### MINERALS PROGRAM INSPECTION REPORT

<b>MINE NAME:</b> Mica Lode	<b>MINE/PROSPECTING ID#:</b> M-1977-144	<b>MINERAL:</b> Quartz (quartzite/ quartzose sandstone)	<b>COUNTY:</b> Fremont
<b>INSPECTION TYPE:</b> Monitoring	<b>INSPECTOR(S):</b> Timothy Cazier, P.E.	<b>INSP. DATE:</b> February 13, 2020	<b>INSP. TIME:</b> 13:20
<b>OPERATOR:</b> Colorado Quarries Inc	<b>OPERATOR REPRESENTATIVE:</b> Aaron Tezak	<b>TYPE OF OPERATION:</b> 112c - Construction Regular Operation

**PROBLEM/POSSIBLE VIOLATION:** Problem: The affected area map, mine and reclamation plans need to be updated and clarified pursuant to C.R.S. 34-32.5-112 (1)(c). The operator must provide updated maps and sufficient information to describe or identify how the operator intends to conduct the mining operation and reclamation.

# Figure 1. M-1977-144 Mica Lode Boundaries & Areas

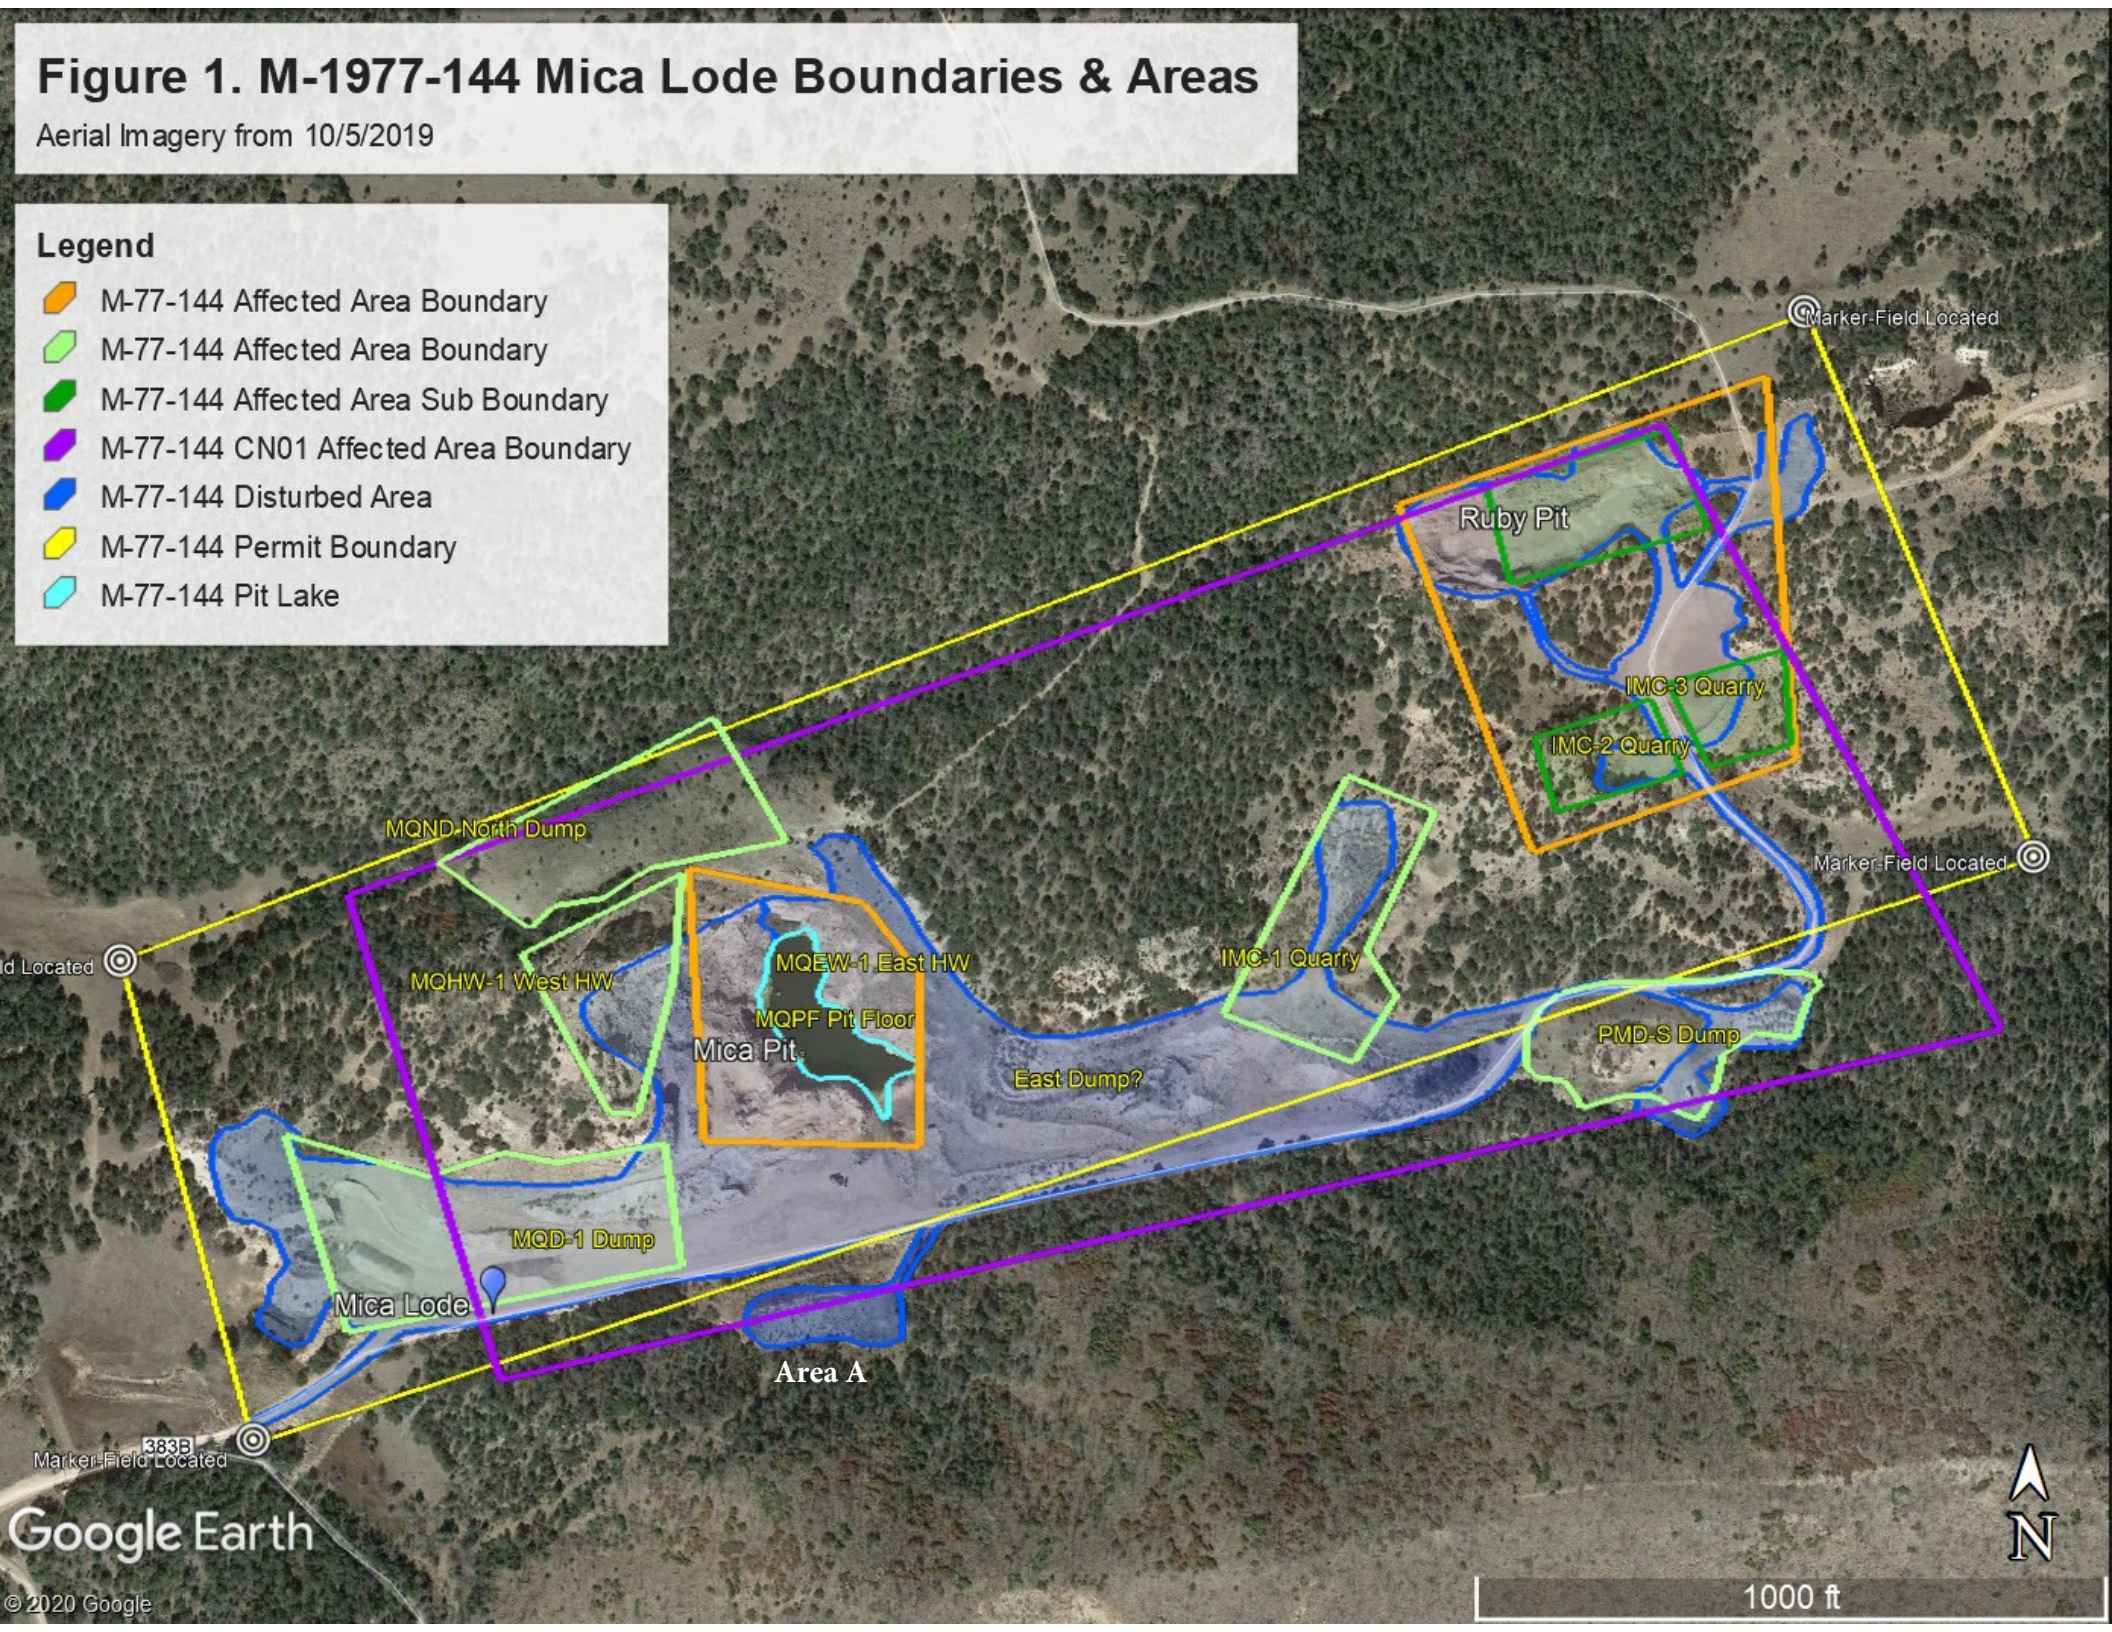
**Off-site Damage:** The 2016 inspection identified and located four permit boundary corners. Most of the operation appears to be within the permit boundary (yellow boundary on **Figure 1**), with the exception of the PMD-S (or PMD-5) dump and an area south of the Mica Pit ("Area A" on **Figure 1**) that was re-disturbed between 2013 and 2016 (based on Google Earth history review). It is possible the affected area boundaries may include all disturbances, but would require adjustments to the permit boundary, as well as clear delineation of the affected areas. The following is a summary of the various boundaries shown on **Figure 1** and their missing areas:

- **Permit Boundary** (~58 acres, yellow line): Does not include the PMD-5 dump and Area A.
- **CN-01 Affected Area Boundary** (~50 acres, purple line): Does not include the northeast corner of the Ruby Pit area; small portions of Area A, the PMD-5 and MQND dumps, and the western portion of the MQD-1 dump.
- **Affected Area Boundaries** (~20 acres, light green and orange lines): Does not include the majority of the disturbed area (outlined in blue) in the central portion of the permit area, the access road, or the wester

**The lack of clearly defined affected area boundaries is cited as a Problem on page 1 of this report.** A technical revision is required to clearly delineate the boundaries for the 46 acres of approved affected area. The revised map must include the area outlined in blue on **Figure 1** (~20 acres), as well as the currently delineated affected areas outlined in light green and orange on **Figure 1**. Updated mine and reclamation plans are required to accompany the updated map in order to clarify the missing items in **Attachment A** and provide the DRMS with a basis to update the financial warranty. The updated map should show locations of stockpiled topsoil and backfill material.

**CORRECTIVE ACTIONS:** The operator shall submit a Technical Revision, with the required \$216 revision fee, to update the affected area boundaries and clarify the current approved mining and reclamation plans to reflect existing and proposed activities by the corrective action date.
